Access Compliance Report

Public Rights-of-Way

Intersection ID: 44484		Main Street: FINN_HALL_AV		Cross Street: NEWFIELD_ST		Location: SE			
ADA ID: F563E5C00EC6		Ramp Type: PerpDiag		Initial Pass/Fail: Fail		Overall Compliance: No		Severity Score: 10	
Codes/Mitigation Info/Possible Solution					Field Measurements/Component Compliance

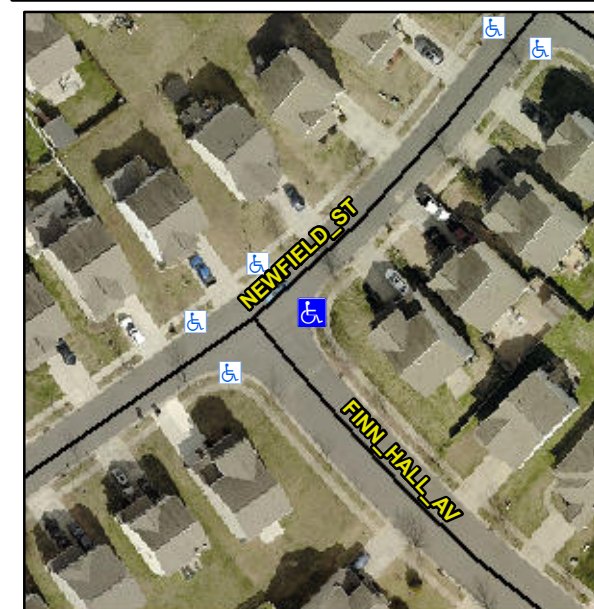
Not Found, R304.5.1, R304.5.3

Compliance	Description	Data	Compliance	Description	Data
N/A	Ramp Length (in)	48.0	Yes	Ramp Slope (%)	5.3
No	Ramp Width (in)	47.0	No	Ramp XSlope (%)	5.0
N/A	Flare Type LT	N/A	N/A	Flare Type RT	N/A
N/A	Flare Slope LT (%)	N/A	N/A	Flare Slope RT (%)	N/A
N/A	Flare Traversable LT?	N/A	N/A	Flare Traversable RT?	N/A
N/A	Landing Length (in)	N/A	N/A	DWS Provided?	N/A
N/A	Landing Width (in)	N/A	N/A	DWS Contrast?	N/A
N/A	Landing Slope (%)	N/A	N/A	DWS Length (in)	N/A
N/A	Landing X Slope (%)	N/A	N/A	DWS Full Width?	N/A
N/A	Landing Curb? (Y/N)	N/A	N/A	DWS Offset (in)	N/A
N/A	Shared Landing?	N/A			
N/A	Gutter Ponding?	N/A	N/A	Gutter Slope (%)	N/A
N/A	Gutter Lip Ht (in)	N/A	N/A	Gutter X Slope (%)	N/A
N/A	Painted X Walk1?	No	N/A	Painted X Walk2?	No
	X Walk 1 Direction	To N		X Walk 2 Direction	To W
N/A	X Walk 1 Width (in)	N/A	N/A	X Walk 2 Width (in)	N/A
	X Walk 1 Slope (%)	4.0		X Walk 2 Slope (%)	0.2
	X Walk 1 X Slope (%)	2.0		X Walk 2 X Slope (%)	4.2

N/A	Ramp inside XWalk1?	N/A	N/A	Ramp inside XWalk2?	N/A
	Road Slope (%)	3.0	N/A	Clear Space?	N/A
	Road X Slope (%)	1.0	N/A	Clear Space to XWalk (in)	N/A
N/A	Any Obstructions?	N/A	N/A	Storm Grate/Utility Hazard?	N/A
	Obstruction Type			Storm Grate/Utility Type	
		N/A			N/A
		Yes		Surface Condition? (G/P)	Good

Remove & Replace Curb Ramp With Two New Directional Ramps or Equivalent.
